86100C-10A

S E R V I C E N O T E

86100C Digital Communications Analyzer

Low Voltage part loaded in 5 V application causes performance to degrade over time. Inspect for low voltage part and replace.

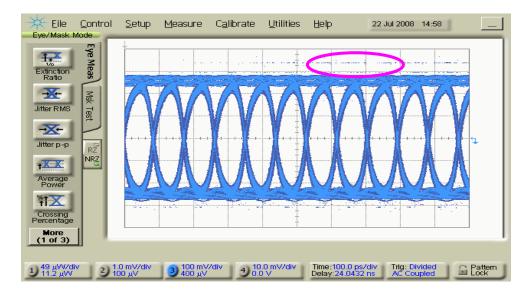
A low voltage part was used in a 5 Volt application. The part will degrade with time and must be replaced. The part is U139 Look Through Memory on the Timebase Acquisition assembly, 86100-68078. There can be various failure symptoms related to the positioning of amplitude samples, like module calibration failures, excessive jitter measurements, failure of look through memory self test, and extraneous amplitude samples. The erroneous samples may not appear at all settings of vertical scale and different settings for different mainframes and modules. There is not a screen for the bad parts other than the manufacturer's part number. Attached are screen shots of examples of the display of erroneous amplitude samples.

Refer to the attached picture for component location. It is labeled as LK TH MEMORY U139. All parts manufactured by and labeled Samsung are good. Parts manufactured by and labeled ISSI must be identified. The low voltage part number is IS61LV25616AL. These parts must be replaced with the 5 V part, part number IS61C25616AL.

Inspect all 86100C's that come in to the service center that are within the serial number range listed and replace either U139 on the PCB or replace the entire assembly.

Use a Metcal part SMTC-X148 to remove the part, and STTC-X44 to install the new IC. For the 500 series x=5, 600 series x=0, 700 series x=1, 800 series x=8

After the inspection or repair, perform the timebase adjustment and a complete calibration that includes all the verification tests.
